IBM appreciates the opportunity to continue to work with the EPA ENERGY STAR® program to develop the Version 2 requirements for the computer server requirements. EPA has made significant progress on refining the Version 2 requirements and IBM believes that the Version 2 requirements, as proposed in Draft 2, are near final form.

IBM offers the following specific comments and recommendations with regard to the ENERGY STAR® Program Requirements Product Specification for Computer Servers: Eligibility Criteria Draft 2 Version 2.0.

Figure 1: Comparison of Idle and Full Power for Four Processor Socket Systems, Minimum Configuration.

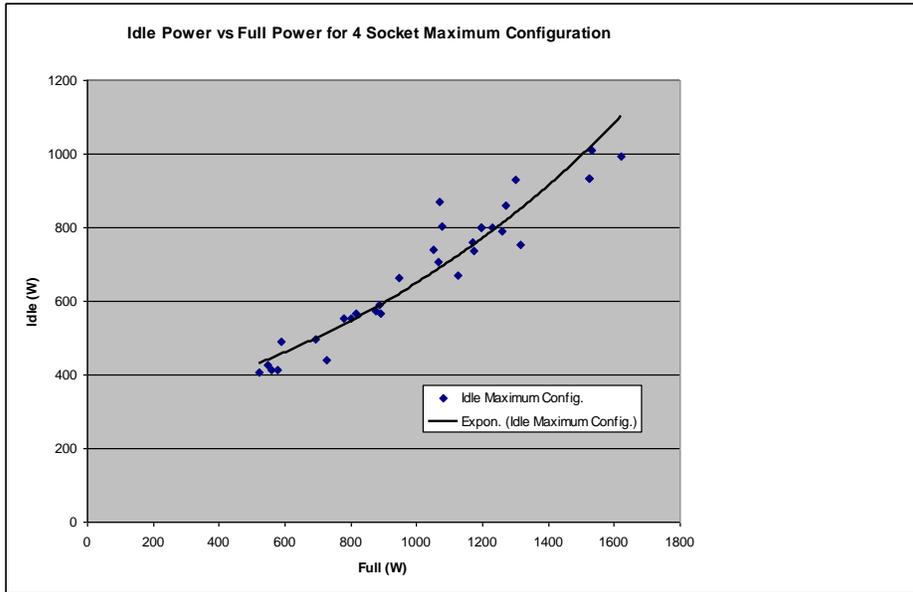
An analysis of ENERGY STAR qualified 4 socket systems shows a wide range in the full load and idle power of the systems. The system power profile is affected by the processor type (lower power versus higher power) and the extent to which the processor and the server system support resiliency and scalability capabilities. While there are a wide range of power profiles for the 4 socket systems, Figure 3 shows that power management capabilities can reduce the power use during idle periods as effectively for high power systems as for low power systems.

IBM proposes that EPA add the resilient and scalable server category to table 3 (page 10 of draft 2) and provide a category specific Resilient and Scalable Server Base Idle Allowance to account for the additional infrastructure and higher processors socket power of this server type and provide additional adders for resilient and scalable components such as Raid 5 controllers and memory buffers. IBM is working to provide available test and vendor data to EPA by July 13, 2012 to provide a basis for setting a Base Idle Allowance and additional component adders for resilient and scalable systems.

Figure 4: (2) Processor Socket Maximum Configurations: Idle to Full Power

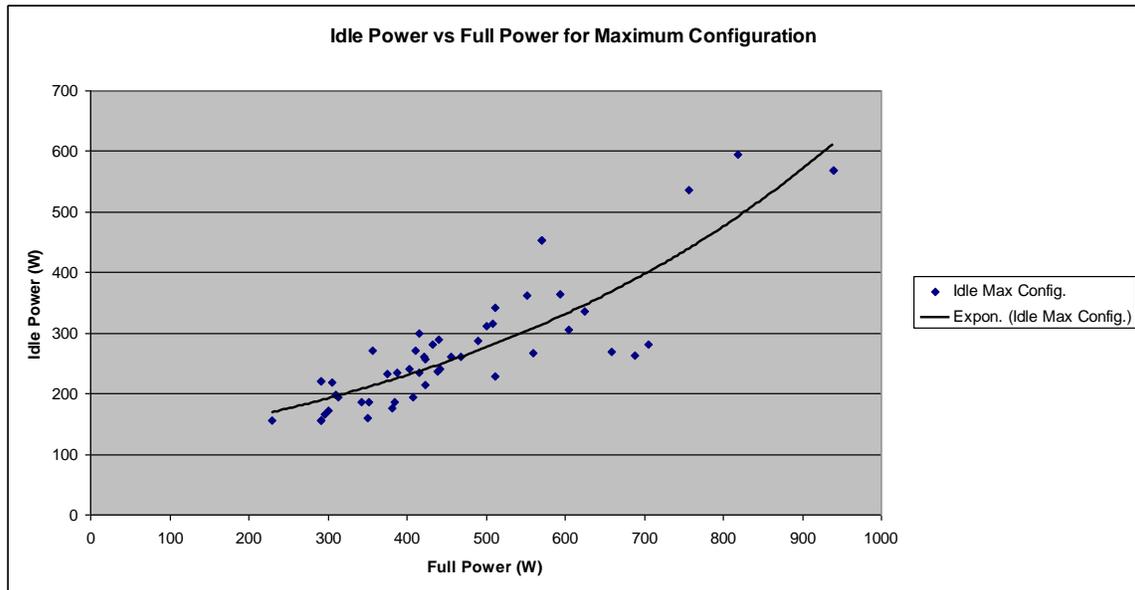
Figure 4 below graphs the idle and maximum power of the current ENERGY STAR qualified two socket servers. The data shows that, similar to 4 socket systems, there is a significant range of power use across the ENERGY STAR inventory of qualified 2 processor socket computer server systems. It should also be noted that there is limited data for resilient and scalable servers in the current ENERGY STAR 1 and 2 processor socket datasets given the difficulty in qualifying these servers to the current idle criteria:

The majority of the 2 processor socket products qualified have minimum configuration full power values of 400 W or less. Higher power systems are difficult to qualify to the idle criteria. However, analysis of the ratio of idle power to the maximum power, the data

Figure 5: Comparison of Idle/Max Power Ratio for 2 Socket Servers

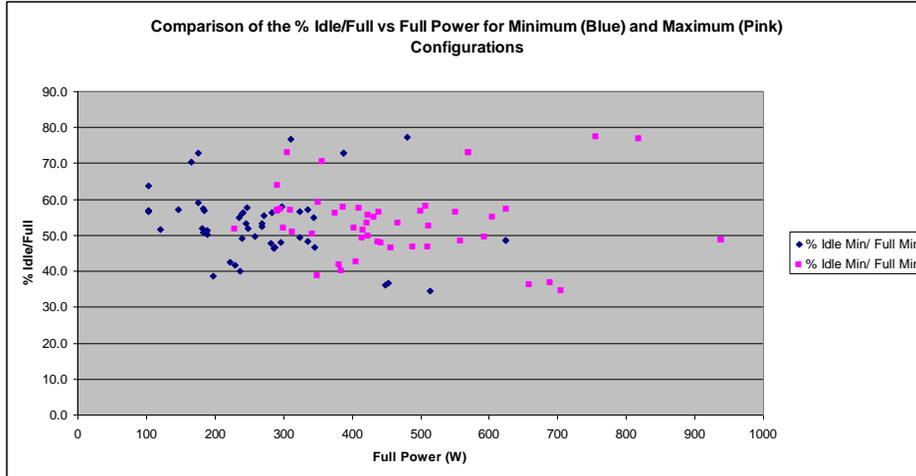
shows that higher power products are competitive with lower power products – they can reduce their energy use at idle by equivalent or better percentage as compared to the low power systems. This is depicted in the graphic below:
